PRELIMINARY OVERALL AREA DEVELOPMENT PLAN # 713A

WILDHORSE SUBDIVISION PRELIMINARY OVERALL AREA DEVELOPMENT PLAN - #713A

The City Staff Development Review Committee has reviewed Wildhorse Master Development Plan (M.D.P) / Preliminary Overall Area Development Plan (POADP) # 713A. Please find enclosed a signed copy for your files. Your plan was accepted however please note the following:

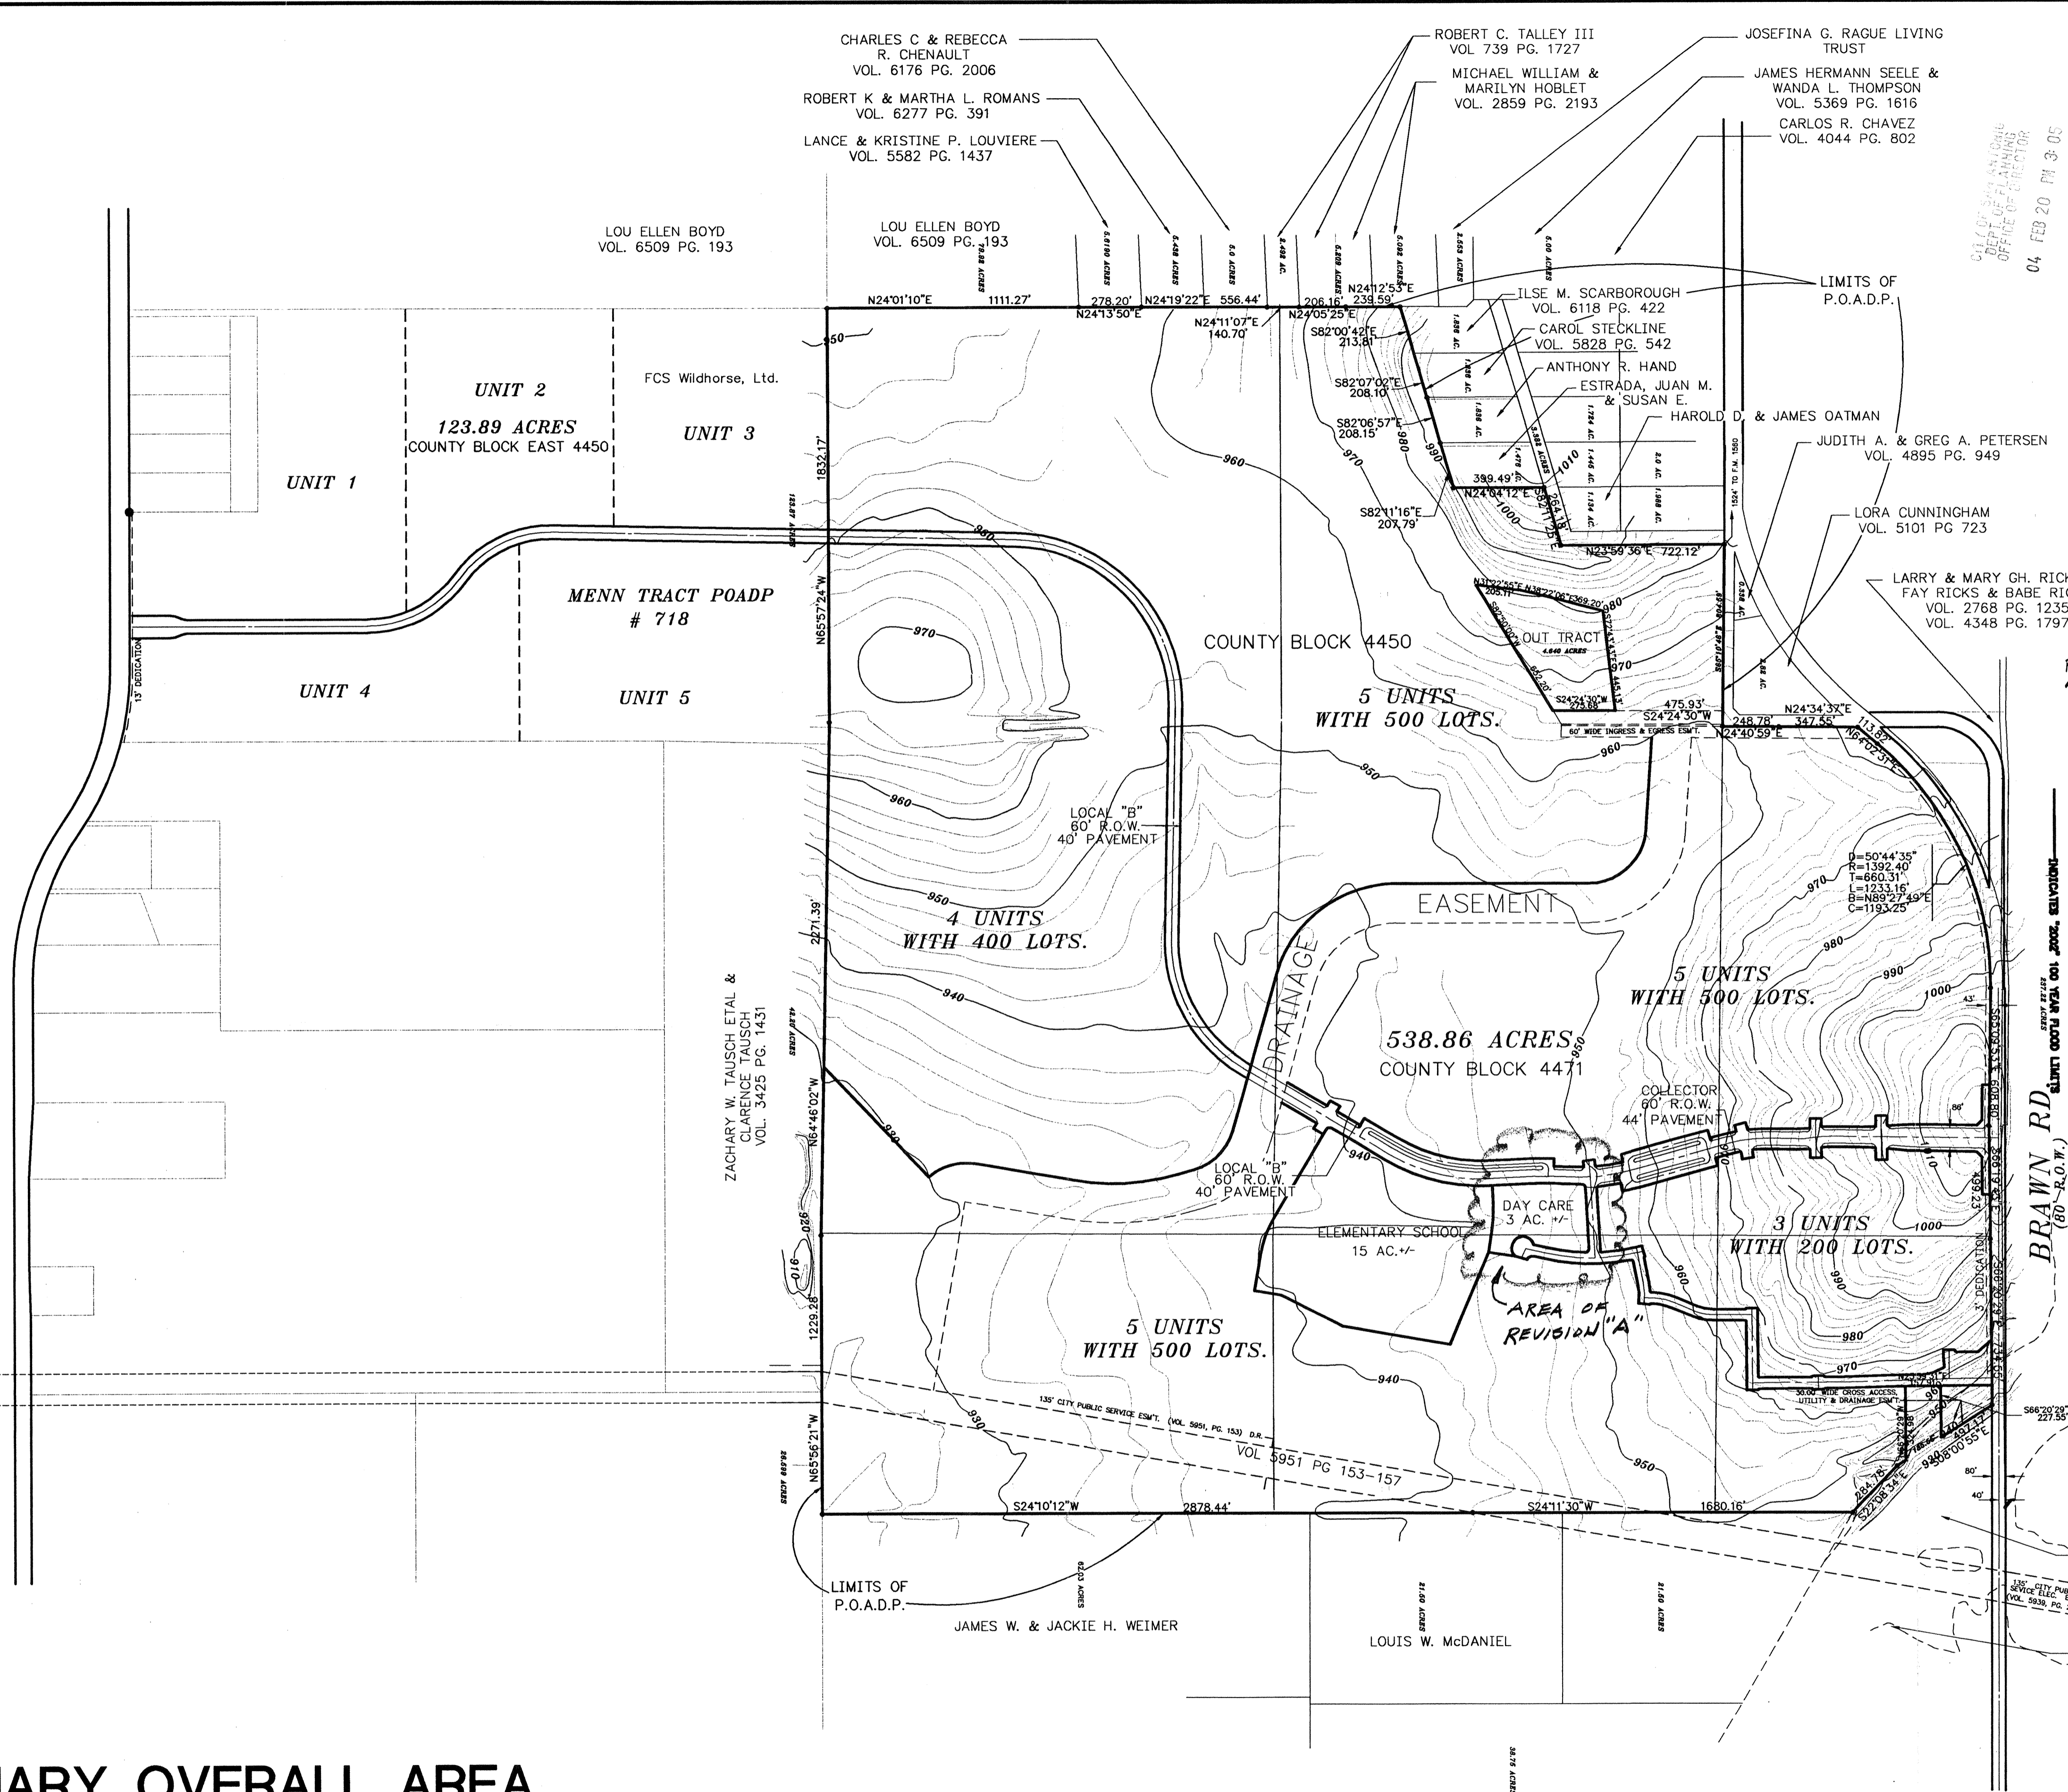
PLEASE ADD A 'GENERAL NOTE' TO PLANS STATING THAT
SIDEWALKS WILL BE INSTALLED IN THE PUBLIC RIGHT-OF-WAY
PER UDC ARTICLE 5, DIVISION.2: 35-506(q.)

SIDEWALKS WILL BE INSTALLED IN THE PUBLIC
RIGHT-OF-WAY PER UDC ARTICLE 5, DIVISION 2:
35-506(q.)

WILDHORSE SUBDIVISION PRELIMINARY OVERALL AREA DEVELOPMENT PLAN - #713A

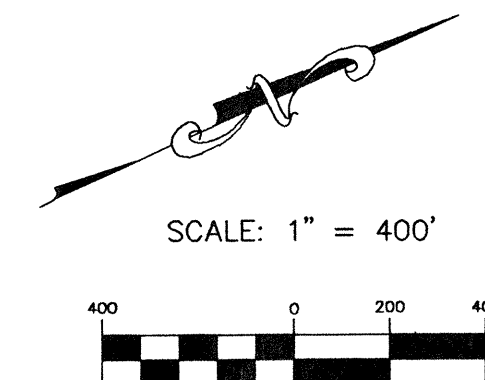
- MDP needs to include design changes per W.F. Castella : Associates. County has had meetings with Castella. Coordination needs to take place with W.F. Castella.
- County has a Capital project on Braun Rd. from Loop 1604 to FM 1560
- County reserves rights to address driveways, street design, sight triangles, ADA requirements, drainage and floodplain issues at time of platting.
- It is understood that this MDP is a conceptual plan and all regulations will be address at time of platting.
- MDP does not represent Roundabout per W.F. Castella.
- Will need connect to Braun Rd @ a 90° instead of existing skew onto Braun Rd.

SIDEWALKS WILL BE INSTALLED IN THE PUBLIC
RIGHT-OF-WAY PER UDC ARTICLE 5, DIVISION.2:
35-506(q.)

Please note this Revision has been reverted back to the original POADP with only one change which is the 3 acre Day Care site verses the 3 acres of residential. We are not trying to change density or any other item. The original POADP had a note that stated "Street configuration is preliminary and subject to change at final design." Most of this area has been platted and recorded and is not an issue nor could it be changed at this point

Disability Access – Note about Sidewalks are on the plan.

OVERALL MASTER PLAN
for
WILDHORSE SUBDIVISION

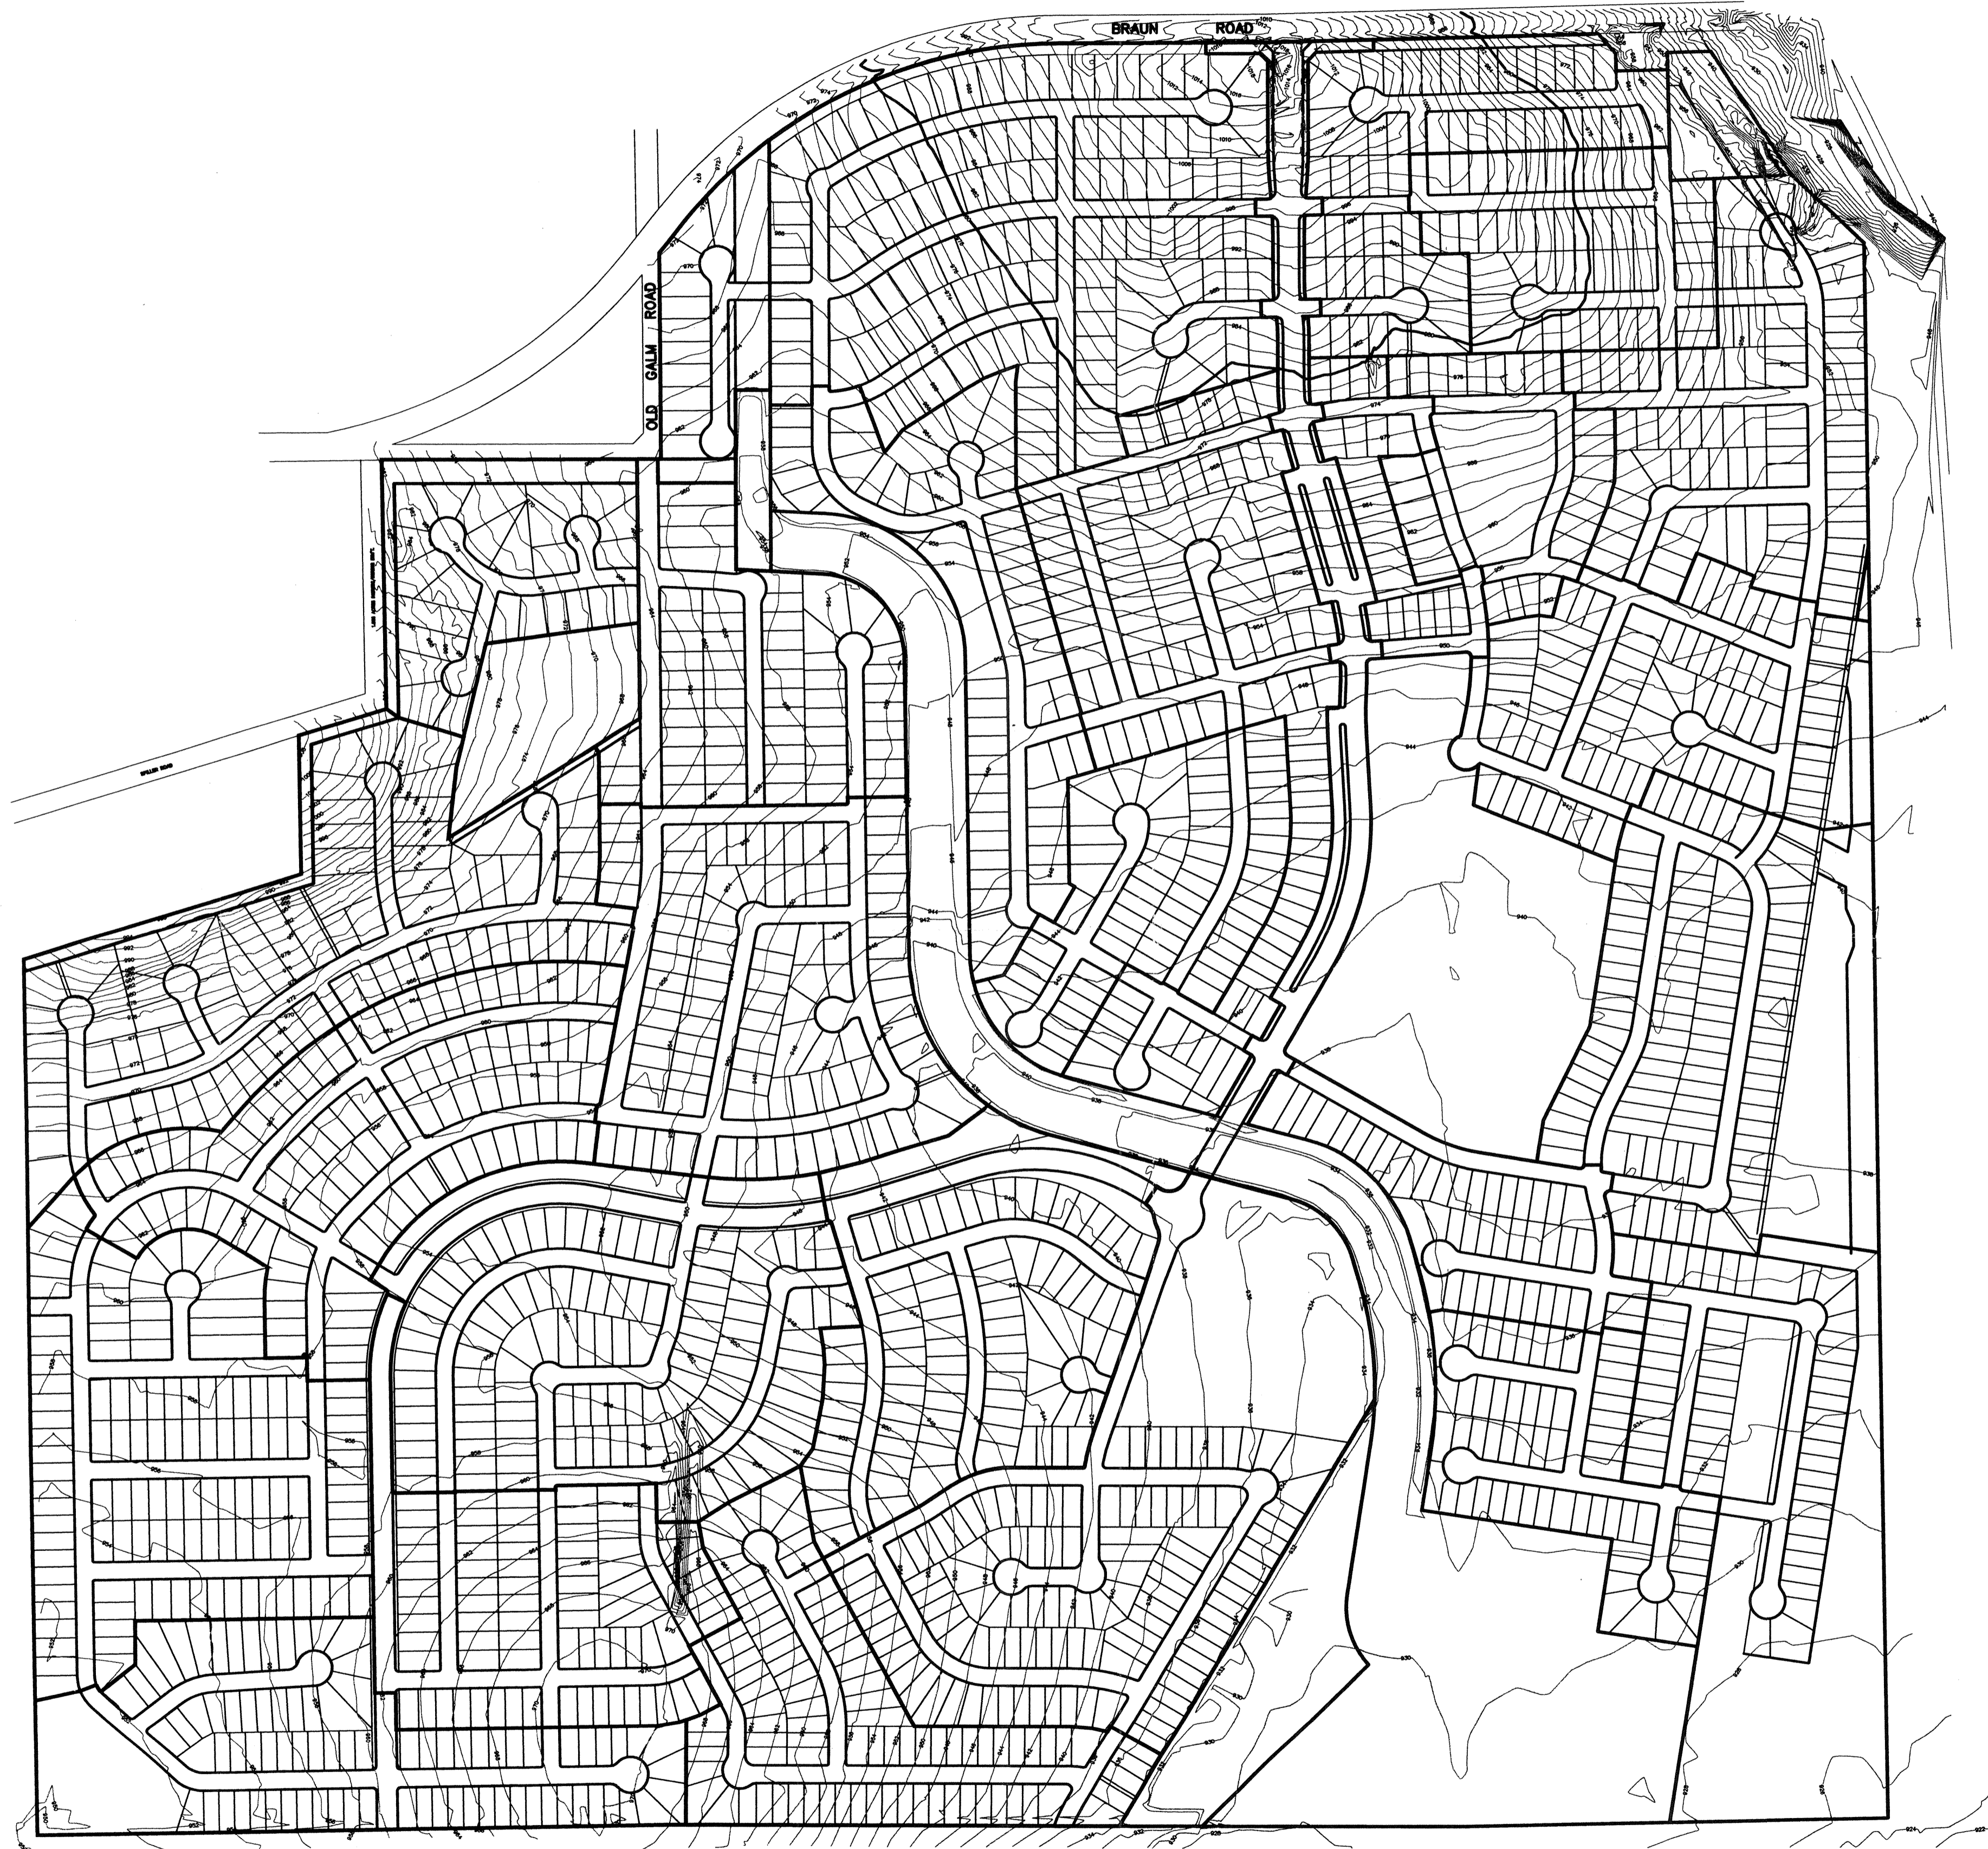
REMARKS: **MR HERRERA: ACCORDING TO ERNEST BROWN, OUR NUMBER OF LOTS EXCEEDS THAT APPROVED BY THE POADP. THE FOLLOWING ITEMS SHOW THAT WE ACTUALLY HAVE 1970 LOTS (WILDHORSE & WILDHORSE OPTION TRACTS) AND THE TOTAL APPROVED BY THE POADP IS 2100. PLEASE CALL ME WITH ANY QUESTIONS; I ANTICIPATE APPROVAL OF WILDHORSE UNIT 16 (PLAT ID#040269). THANK YOU.**
